UNITED STATES ENVIRONMENTAL PROTECTION AGENCY
WASHINGTON, D.C. 20460

March 6, 2012

Revised Proposed On Mode Power levels for displays with a diagonal screen size less than 30" and computer monitors with a diagonal screen size 30" or greater.

Figure 1: Revised On Mode Power Levels (with Resolution Subtracted)

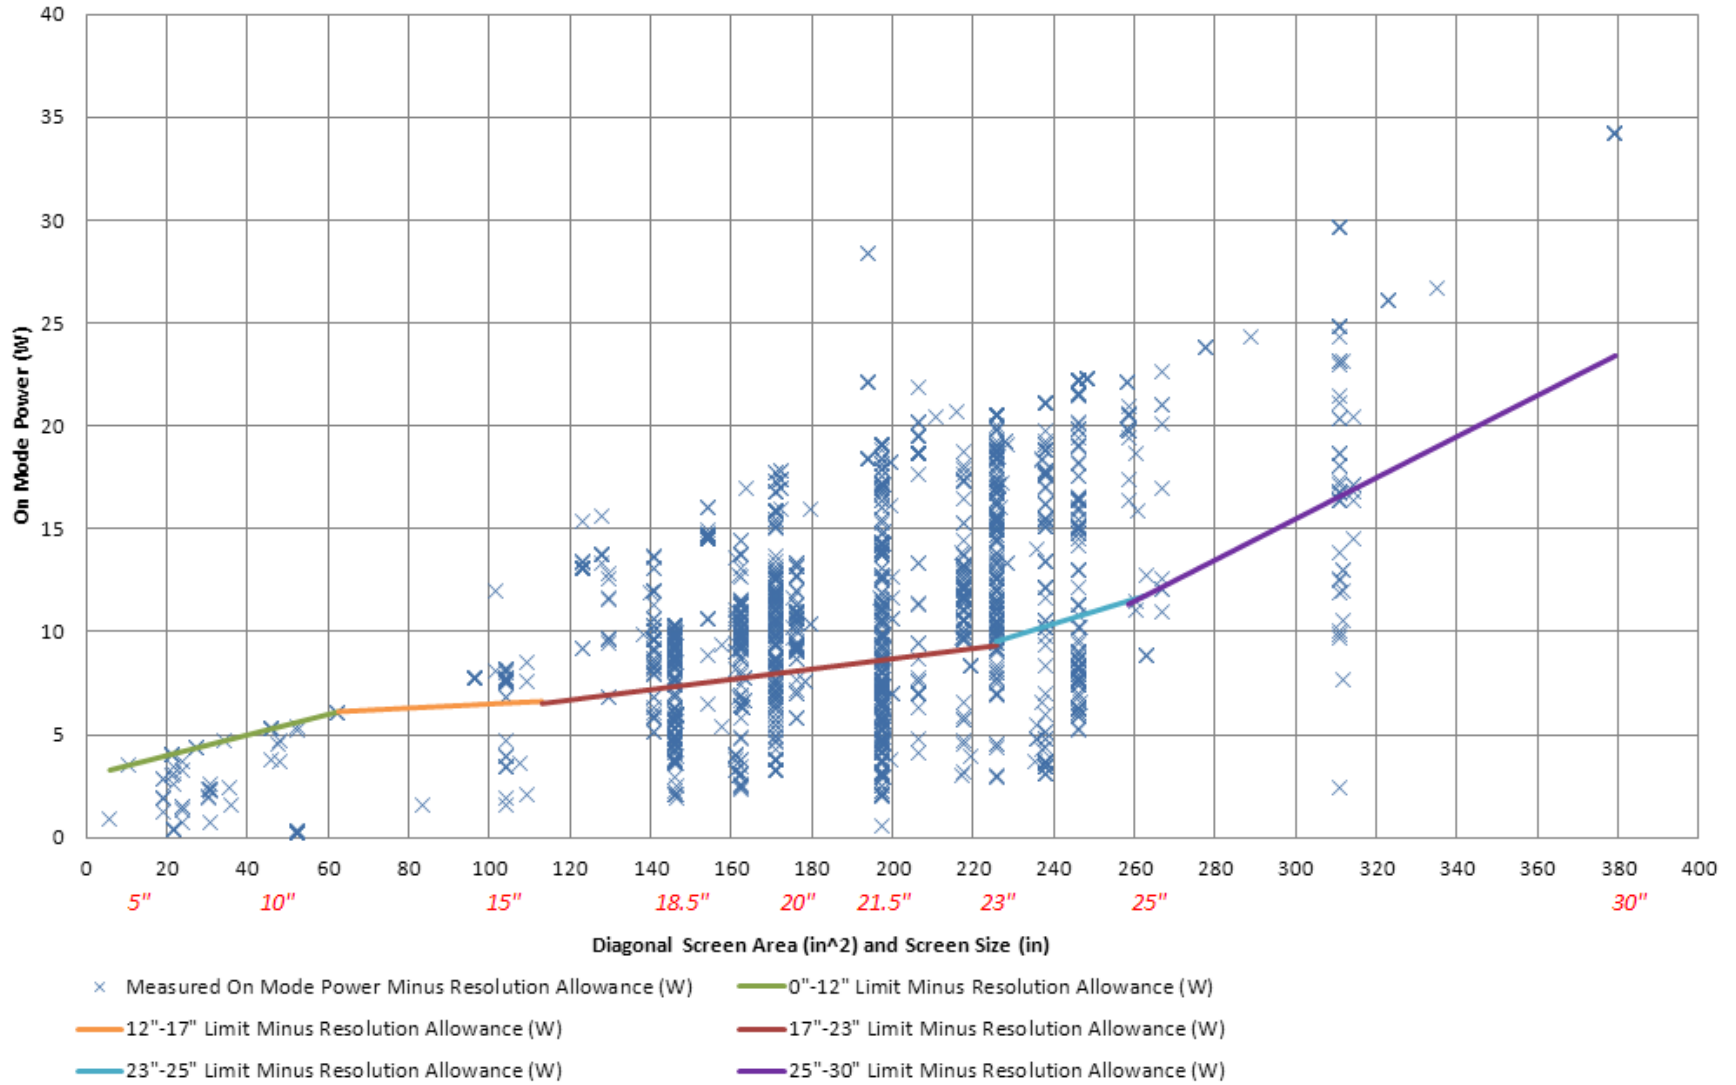
Based on initial comments received on the February 22, 2012 webinar and further information received from stakeholders over the past week, EPA has revised the On Mode power levels for displays with a diagonal screen size $0" < d < 30"$ and any computer monitors with a diagonal screen size 30" and larger to allow greater product qualification in key sizes that are popular with consumers, namely 19, 20, 22, 23 and 25 inch monitors. The revised On Mode Power levels provide greater selection of top performing products that remain cost effective. EPA requests that stakeholders submit their comments based on the revised On Mode power levels proposed in this memo by the extended comment deadline of March 21, 2012.

- Displays $< 12"$: $P_{ON} = (6.0 \times r) + (0.05 \times A) + 3.0$
- Displays $12" \leq \text{Size} < 17"$: $P_{ON} = (6.0 \times r) + (0.01 \times A) + 5.5$
- Displays $17" \leq \text{Size} < 23"$: $P_{ON} = (6.0 \times r) + (0.025 \times A) + 3.7$
- Displays $23" \leq \text{Size} < 25"$: $P_{ON} = (6.0 \times r) + (0.06 \times A) - 4.0$
- Displays $\geq 25"$: $P_{ON} = (6.0 \times r) + (0.1 \times A) - 14.5$
